BLOOMINGTON HISTORIC PRESERVATION COMMISSION

Thursday, January 26, 2017

COA-17-01

925 E. University St.: Elm Heights
Petitioner: Matheu Architects

① SOUTH ELEVATION - OPTION A
SCALE 1/4" = 1'-0"

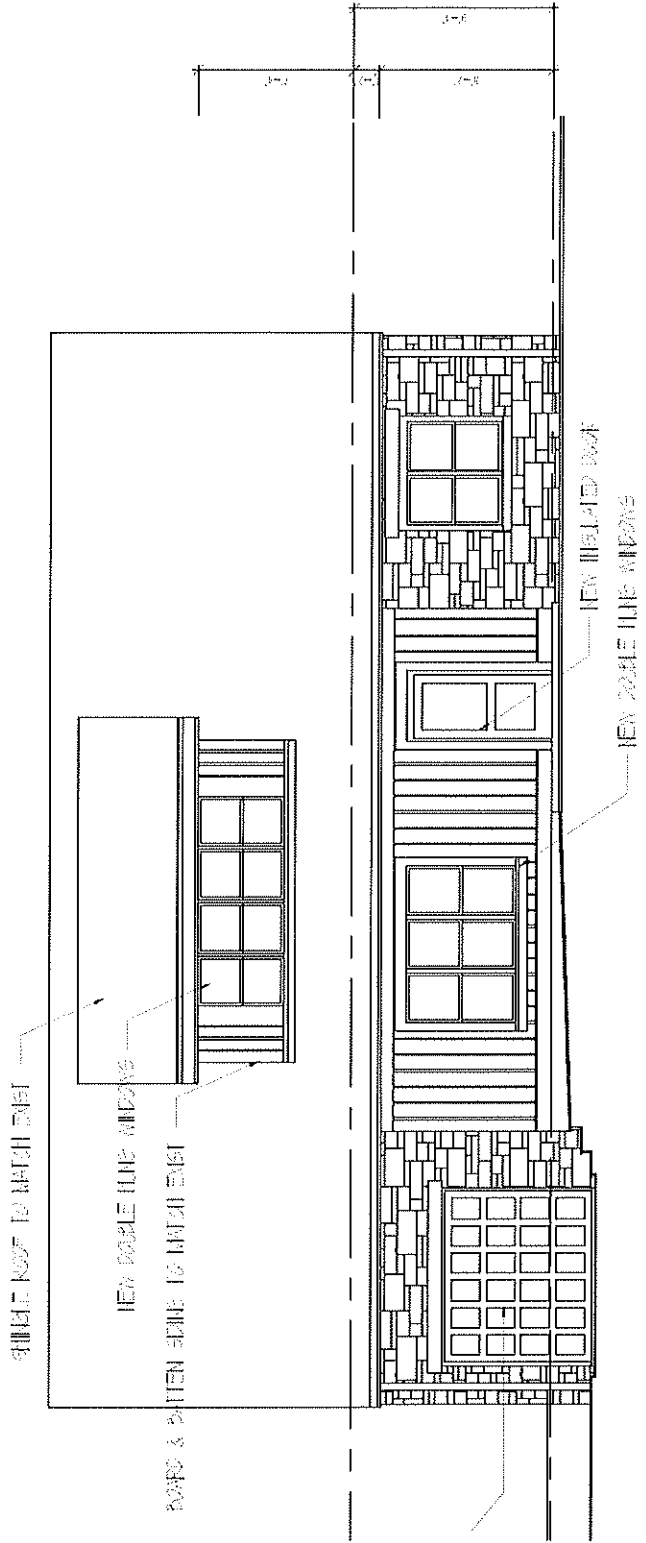
-Option A is a scaled down version of the originally proposed dormer. The roof bridge extends from the existing roof ridge, providing a steeply high pitched roof. It uses board and batten to match the recessed porch material and has a vent to match the gable end vents in the

original house. It has a band of four double-hung windows.

Per the Elm Heights Design Guidelines, "Size and scale of additions should not visually overpower the historic building or significantly change the proportion of the original built mass to open space." Per the Elm Heights design guidelines and the Secretary of Interior Standards, the second story addition is not a recommended treatment and will diminish the historic character of this style of house.

SHEET NO. A301-B

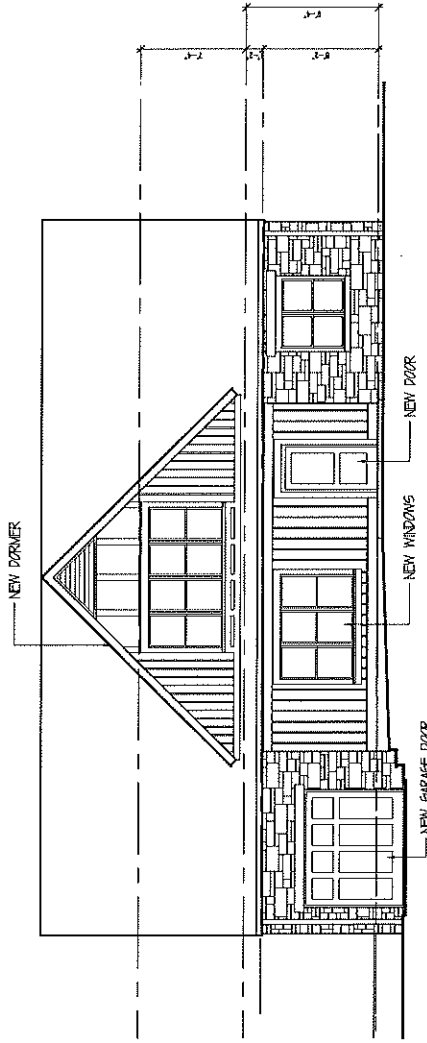
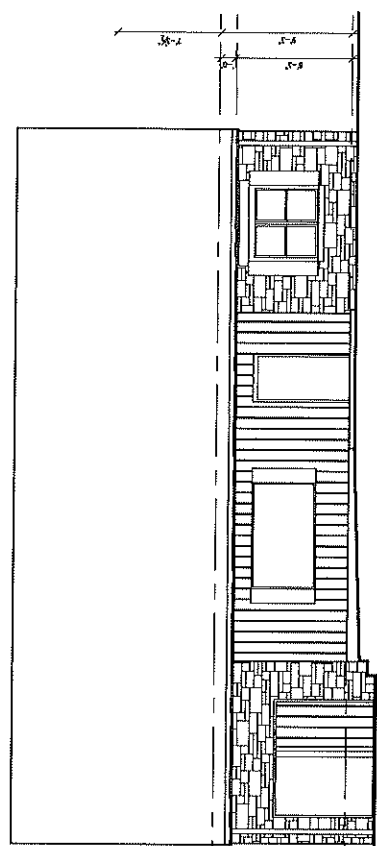
-Option B is shed roof with board and batten to match the recessed porch material. It has a band of four double-hung windows.

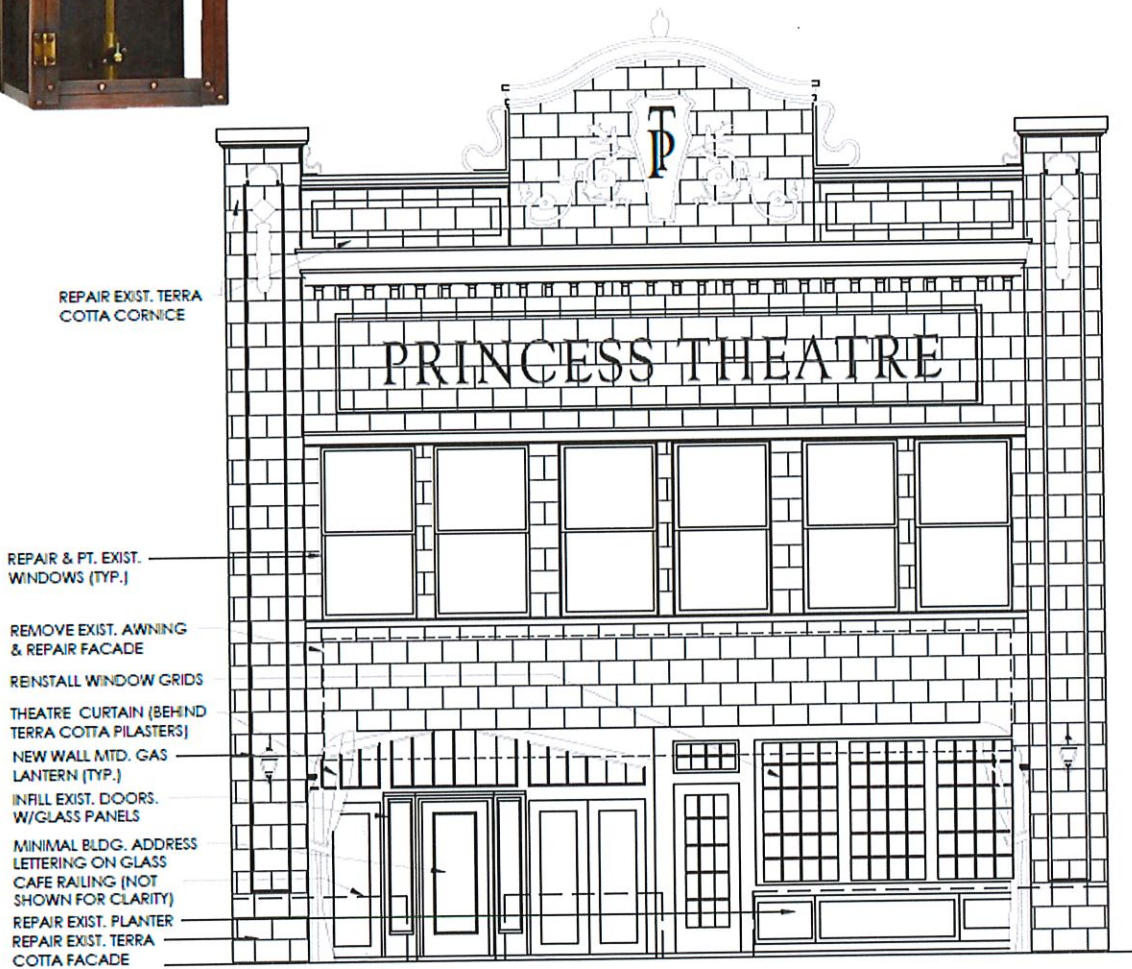
The photo on the left shows the theater without the awning and with the window grids. The petitioner is looking to repair and restore much of the terra cotta and the 1920s era

grandeur. The box office currently has two doors on either side, but the proposal is for a single ADA accessible entrance from the front. The box office form will remain and the two doors will be closed off and infilled. The wall mounted lanterns will be similar to the one to the left. It would be installed on either pilaster on each side of the entrance. The theater curtains would be installed behind the terra cotta pilasters. The café railing will be free-standing, ground attached, and will be a custom made black or dark bronze railing that is complementary to the building.

Staff is supportive of the restoration of the front façade by removing the awning and returning the grids to the windows. The box office form will remain and the doors have been altered and therefore staff is supportive of the installation of an ADA accessible entrance from the front of the box office. Staff is concerned with the installation of the wall mounted lanterns as it could damage the glazed terra cotta. If they were mounted only into the mortar joint, it would be preferred. Staff is supportive of the installation of theater curtains behind the terra cotta pilasters. The café railing is free-standing and ground mounted and therefore will not interfere with the historic fabric. Staff is supportive of the railing.
